Developments of National Significance (DNS)
Application by Rhoscrowther Wind Farm Ltd

Proposed Construction of
3 x 135m high wind turbine generators
(model Vestas V117)
and miscellaneous works at

Evidence
of
Geoffrey SINCLAIR
for
CPRW Pembrokeshire Branch

PEDW ref DNS/3261355

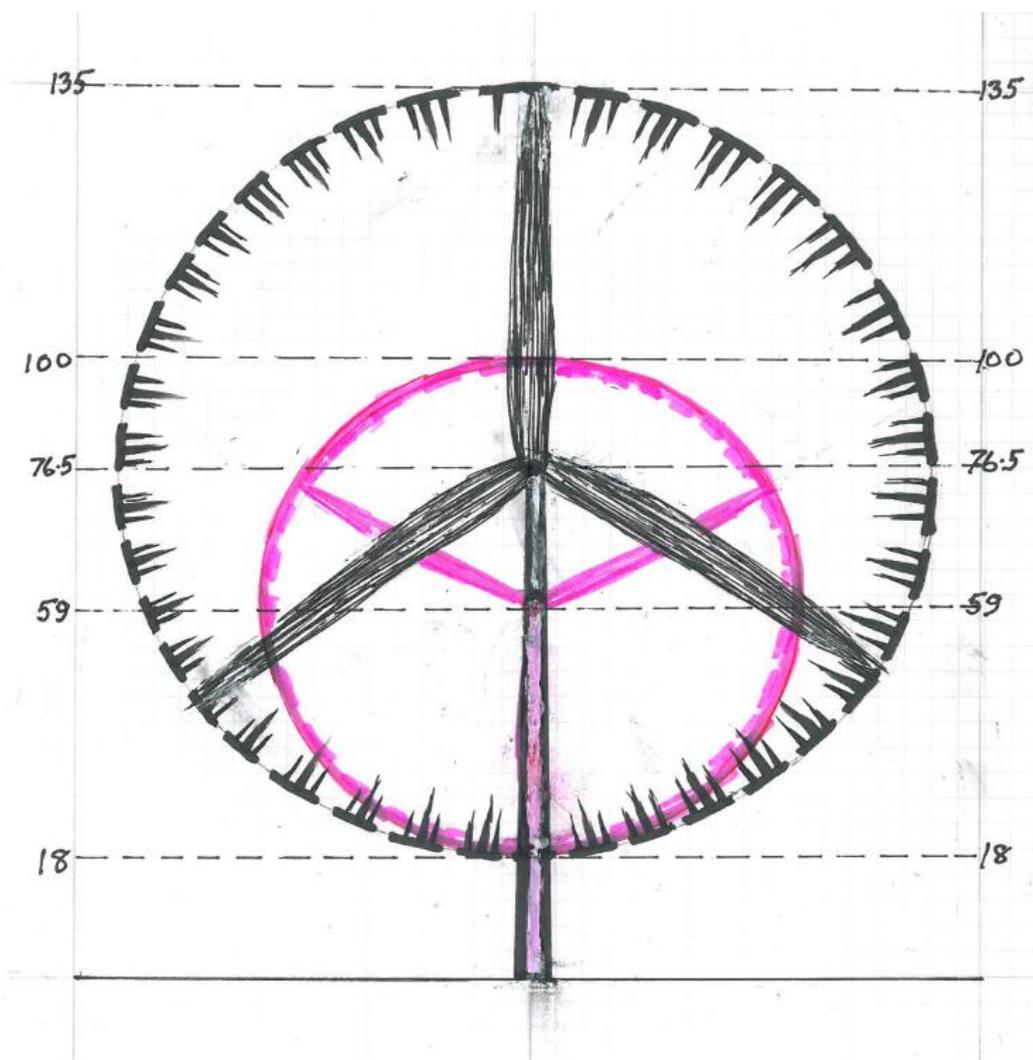
2.1.5 By using three but more powerful 4.3MW machines, RWF have barely increased the total generating capacity over the original 5-turbine scheme – 12.9MW rather than 12.5MW. Moreover, in the process they have significantly increased the tip height of each from 100m to 135m, and have thus more than doubled the blade-swept area of each from 5281m² to 10,751m². As a result, the total blade-sweep from the 3 turbines has actually gone up from 26,405m² in the original 5-turbine scheme to 32,254m² – an increase of 22%.

2.1.6 The additional potential impact of the proposed turbines is even greater than the statistics would suggest. Both the 100m and the 135m turbines have blades which at their lowest point sail only 18m above the ground.

This means, as shown in the following sketch, which is based on ES Figure 1.3, that the extra sweep of the proposed turbines' blades (in black) **is above - i.e. higher and wider than that of the original machines** (in pink). Given that the overall blade sweep from just the 3 turbines is 22% greater than that from the previous 5, this is a salient factor in assessing their impact.
